Community for Accurate Impact Assessment of the Dalton Power Station (CAIAD)
"Altjira"
Alton Hill Road
Gunning NSW 2581
Correspondence to: amakeig@bigpond.net.au

SUBMISSION IN RESPONSE TO THE DALTON POWER PROJECT - REQUEST TO EXTEND LAPSE DATE

Figure 1: Original and actual images of the Dalton power station

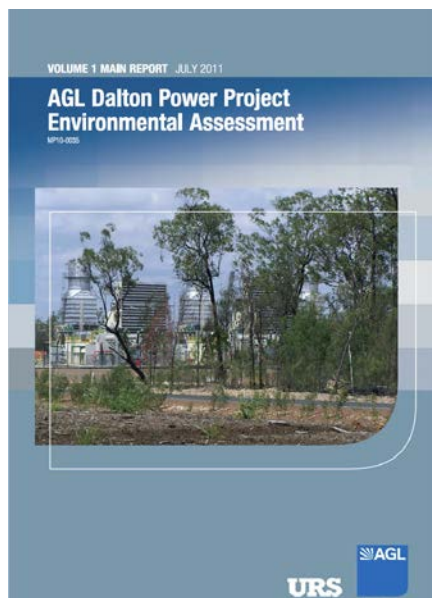
AGL has conducted itself appallingly in the approval process. From the outset they have sort to deceive and underplay the impact of power station on the community. One of the requirements of the Director General is that the proponent consults with the community. AGL has failed to do this. Unbelievably the picture on the front of the EA wasn't even a image of the Dalton power station, rather it was an image of the much smaller Leaf's Gully power station (see Figure 1).

For many in the community their review of the project amounted to looking at the front cover of the EA. To put an incorrect image on the cover is unforgiveable. For this reason alone the project should have been rejected.

Figure 2: Lot boundaries - Dalton April 2017, AGL property 'yellow', new subdivision 'pink'

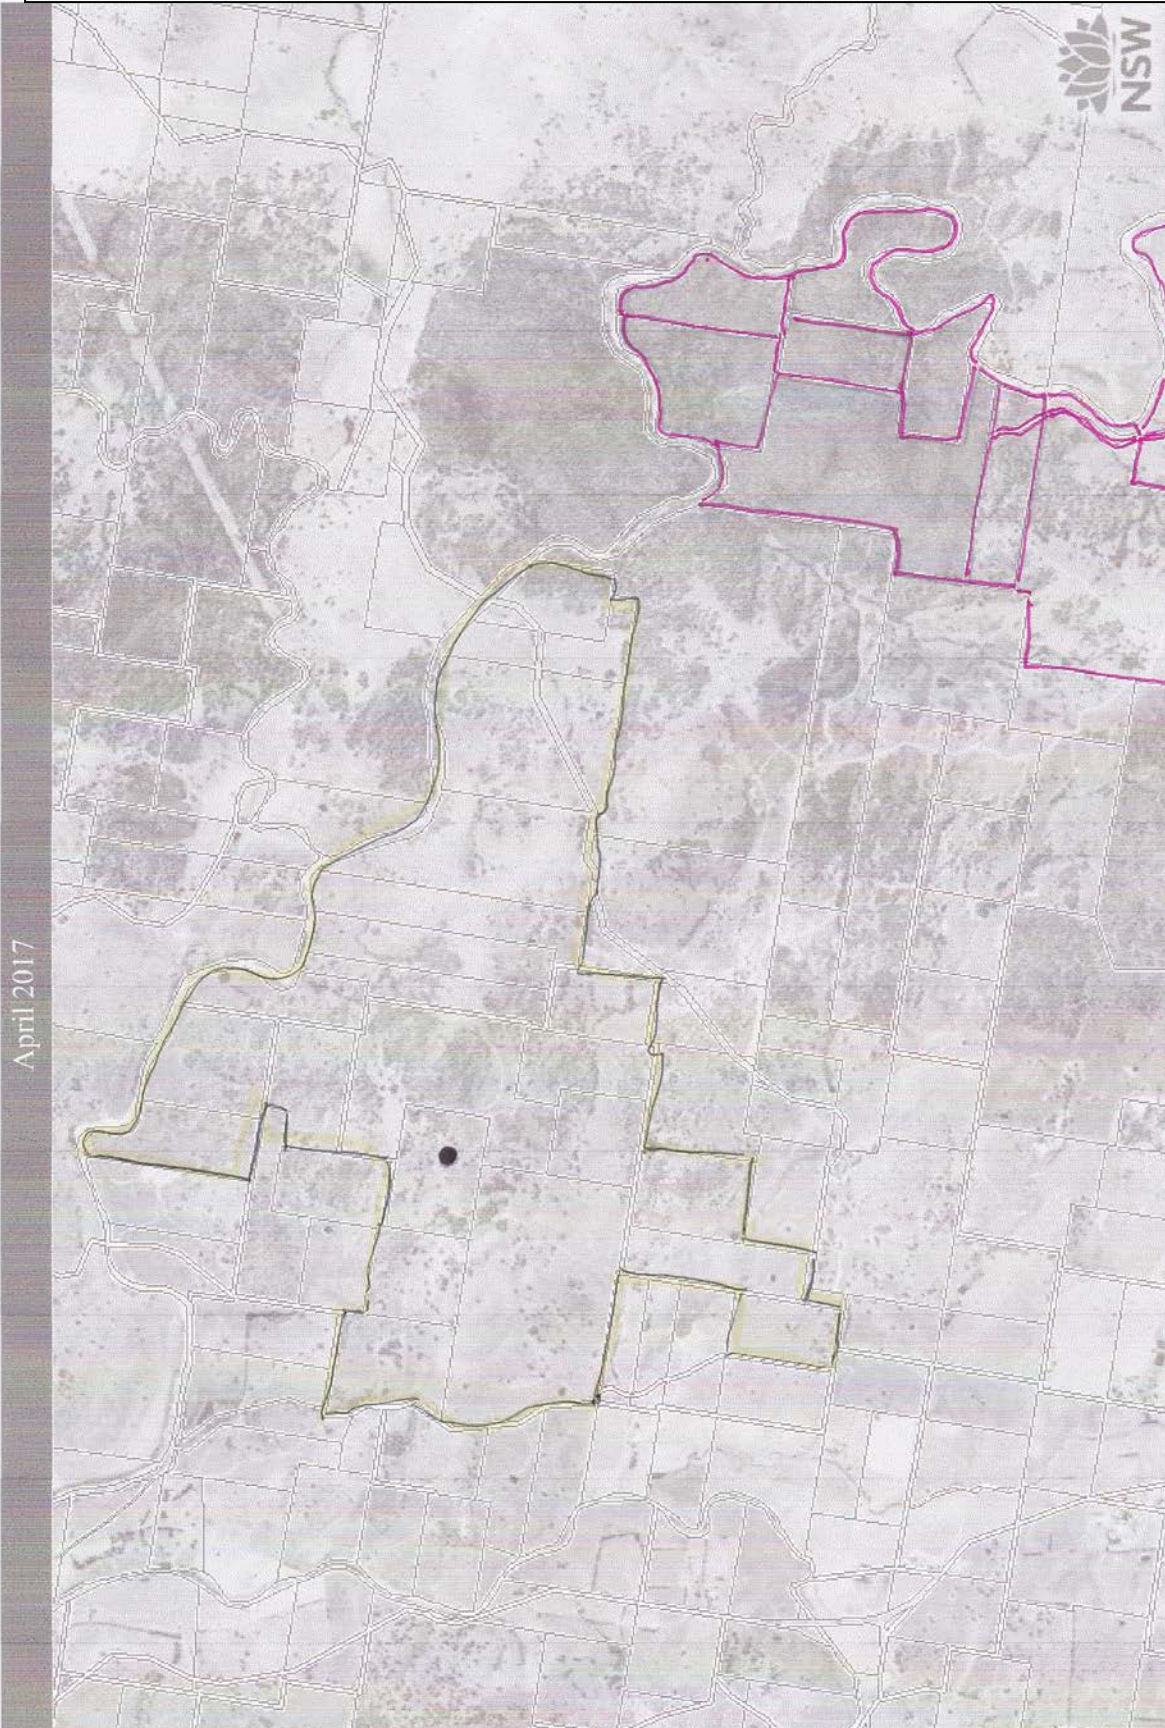
There have been significant demographic changes to the region since October 2012 when AGL announced the suspension of the DPP. A subdivision has gone ahead in close proximity to the proposed site and there are some 18 new impacted people in the community. There is real risk that the power station will exceed the NSW INP criteria at these new properties (see Figure 2: Lot boundaries – Dalton April 2016– yellow highlighted DPP property, pink new Lots). The *MAJOR PROJECT ASSESSMENT: Dalton Power Project Walshs Road, Dalton (MP10_0035)* by DP&I in Table 13 indicates the night time criteria will be exceeded for nearby receptor J. This is expected to be a significant underestimate of the actual exceedances at these new properties. The exceedances reported in Table 13 occurred even though the noise assessment failed to model adverse weather conditions specific to the region, and the amplification from modelled adverse conditions was well below the 5-10dB, that the NSW INP policy says occurs on average.

Figure 3: Goulburn weather – inversions and average wind speed

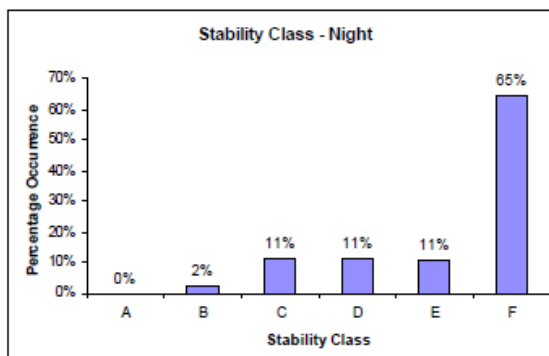
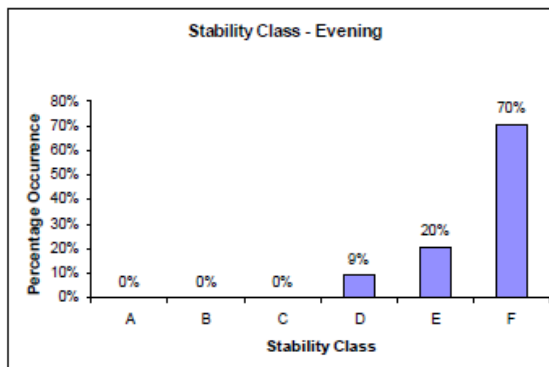
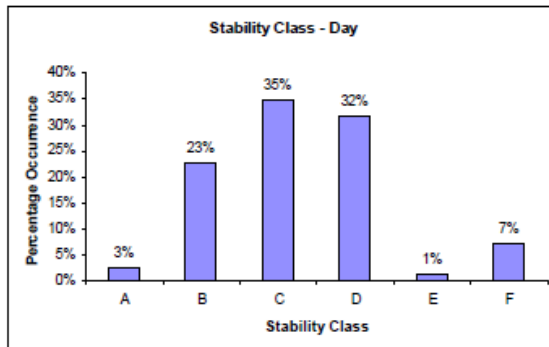
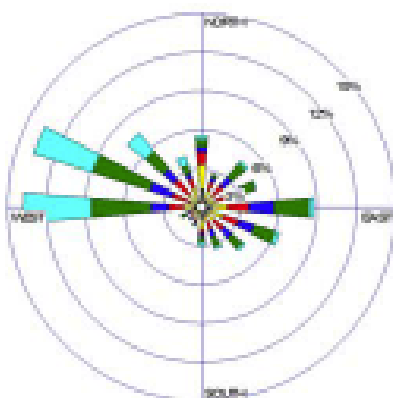
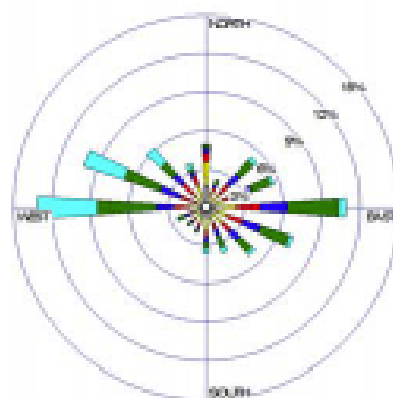
The Goulburn weather data showed that in the evening and night F class temperature inversions occurred for 65-70% of the time and average wind speeds every year from 1999 to 2006 exceeded 4m/s (14km/hour) (see Figure 3 below).

These conditions were modelled by AGL/URS as adverse weather conditions of the region. However they are in fact average weather conditions of the region (see Table 5-1 Prevailing meteorological conditions; and Table 5-5 Meteorological Conditions used in Noise Modelling, below).
